Interface Control Document, ICD

Trans Mon Suspension (TMS) to Interferometer Sensing and Control (ISC), Suspension (SUS) and Systems (SYS)

C. Torrie, July 20, 2010

v2 - is a draft prepared for TMS weekly meeting on 21st July 2010

Figure 1 Figure of Top level TMS assembly, D0902083. Please note X and Y indicators were added by systems to explain CG requirement in section 2.1.3 only.

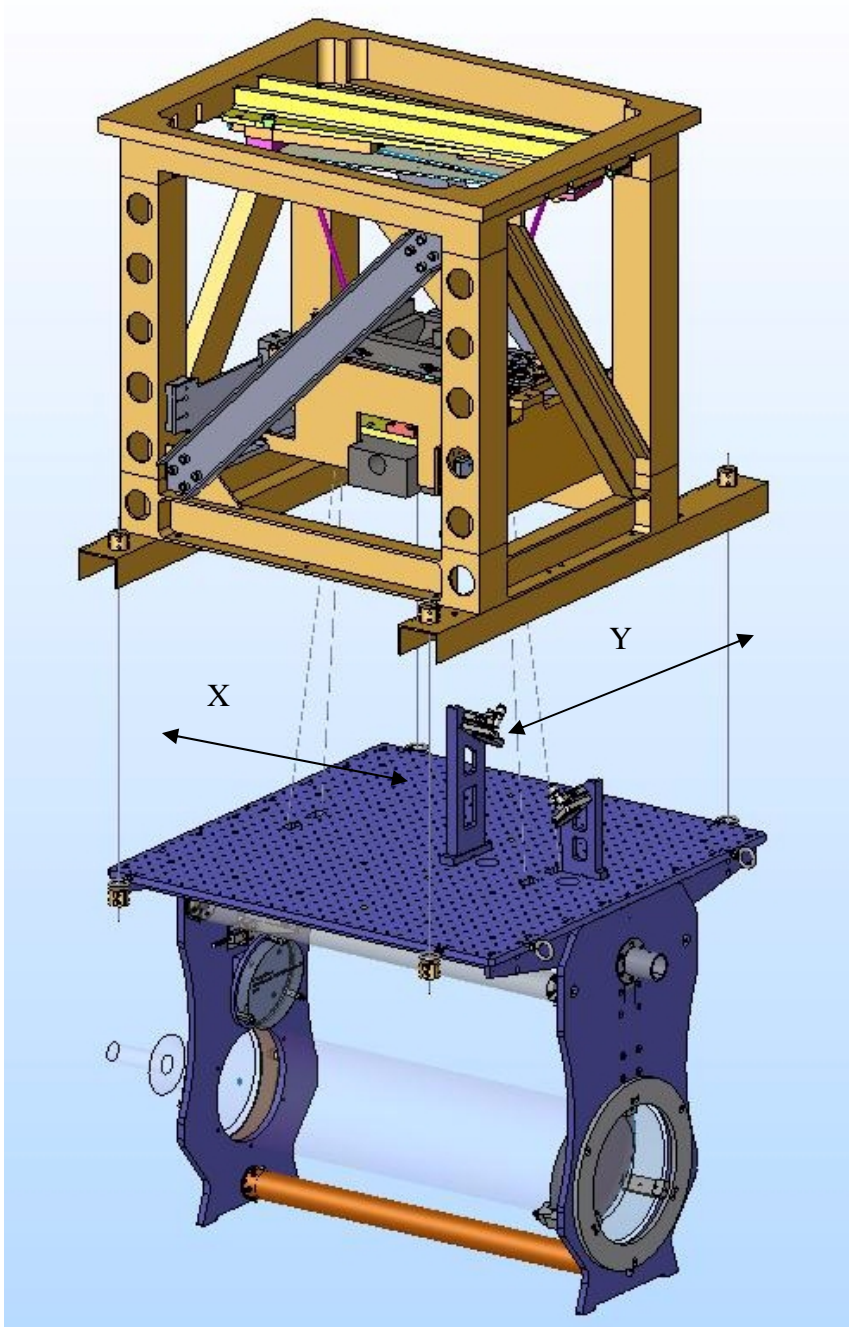
The CG location in both X and Y is at the center of the wire pattern, as shown in the figure below. ISC will make an effort to have the CG of the ISC components (as defined above) at the center of the wire pattern. There is provision for to adjust this with adjustable mass on the table.
